RE: BC Realty Trust, Applicant – Property: 47 ½ - 57 Kimball Road – Request for Waivers – Peer Review

Relative to the above-referenced, this letter is being provided to address the comments contained in the design review Memorandum provided by Stantec Consulting Services, Inc. dated September 23, 2015. Stantec's comments are recited, below, as the numbered comments, with the Applicant's responses following.

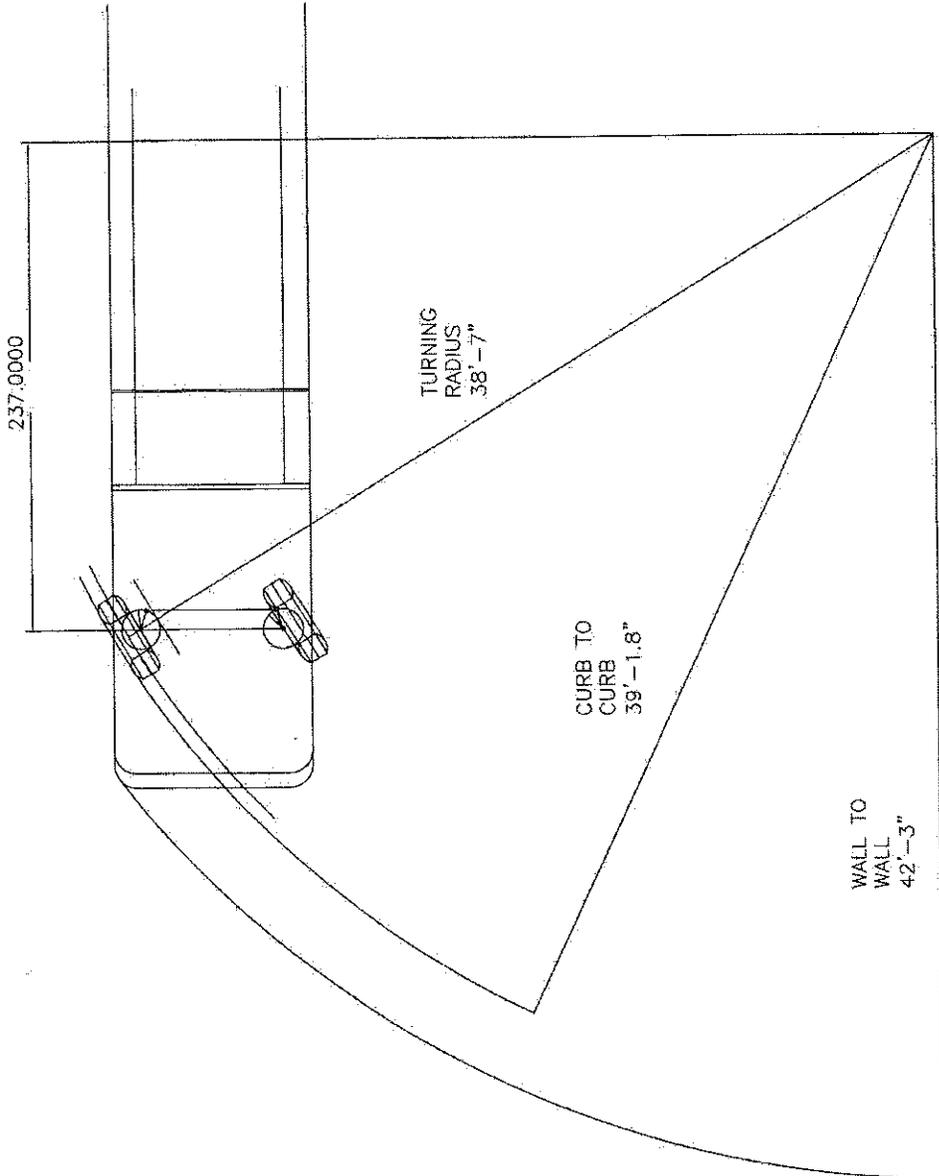
The cul-de-sac needs to be able to handle the turning radius of the FD's ladder truck. I have enclosed the turning radius that is required. That is standard for the projects going on in town.
